IMPORTANT SAFETY RECALL

Airstream Interstate Motorhome

NHTSA Recall Number 15V-658

Problem: Airstream Grand Tour and Interstate Extended Vans could have loose electrical connections and an 8 gauge interior wire harness grounding wire installed in a way that could cause this wire to overheat and catch fire if the main body ground becomes loose or disconnected and the overall system is experiencing a high amperage load condition.

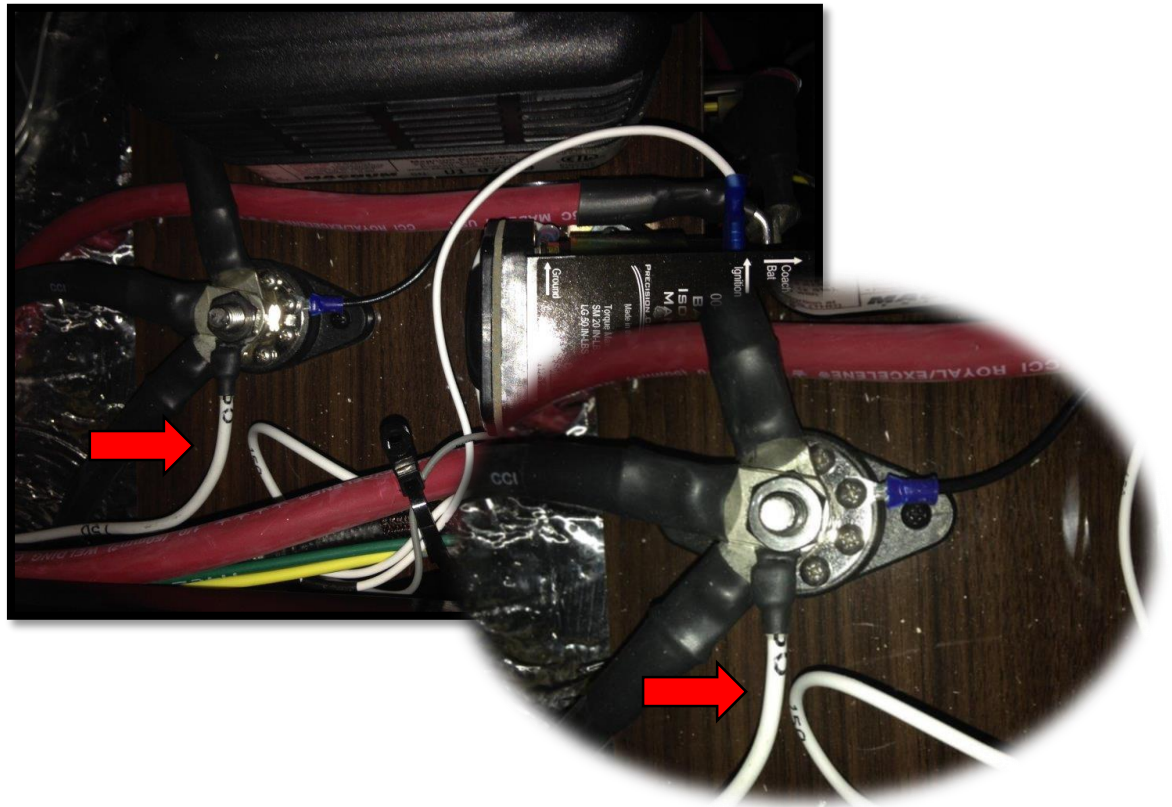
Step 1: Locate the Magnum Inverter/Converter compartment in the unit underneath the Roadside Lounge seat.

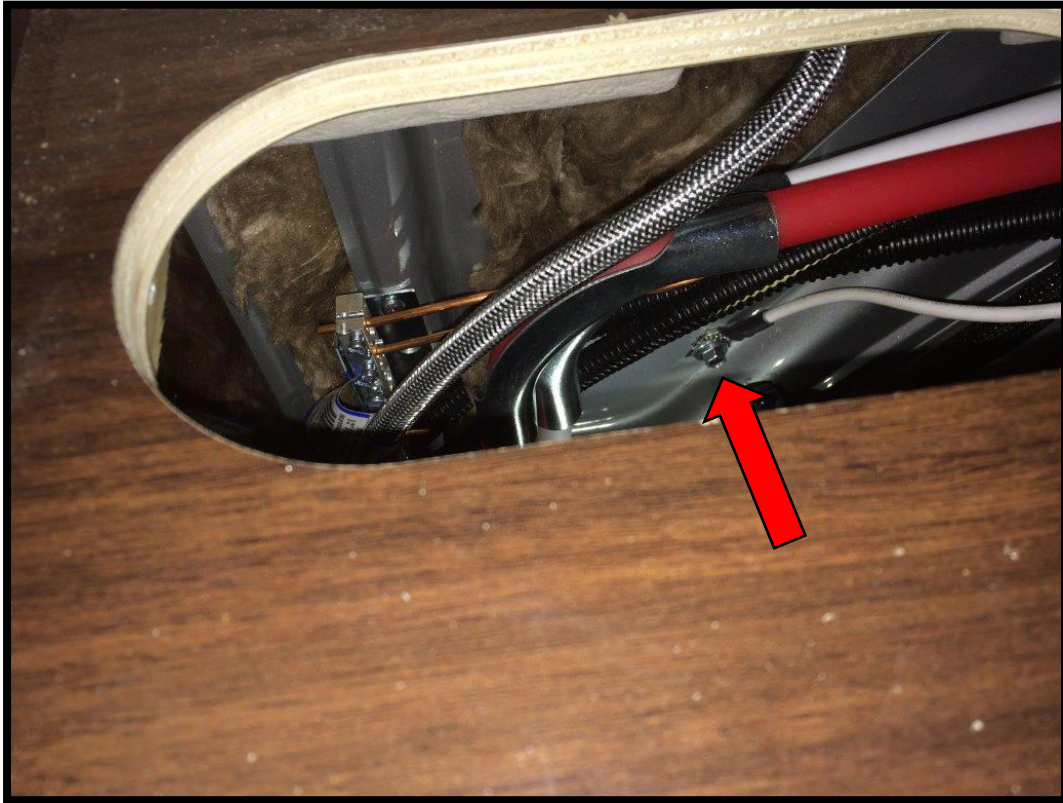
Step 3: Locate the bundle of wires grounded to the left of the Magnum. Remove the 8Ga. white wire labeled #150, identified below.

Step 4: Remove the roadside cup holder from behind the jack knife seat. Pull the white wire removed from the bundle form under the jack knife seat, to the roadside wall under the cup holder.

Step 5 : Using the provided self-tapping screw and washers, attach the white wire to the side wall of the Interstate, as pictured below. Tighten the screw to 150 inch lbs. To make sure you make the best ground possible, mar the surface with some sandpaper. Make sure to coat the surface once attached.
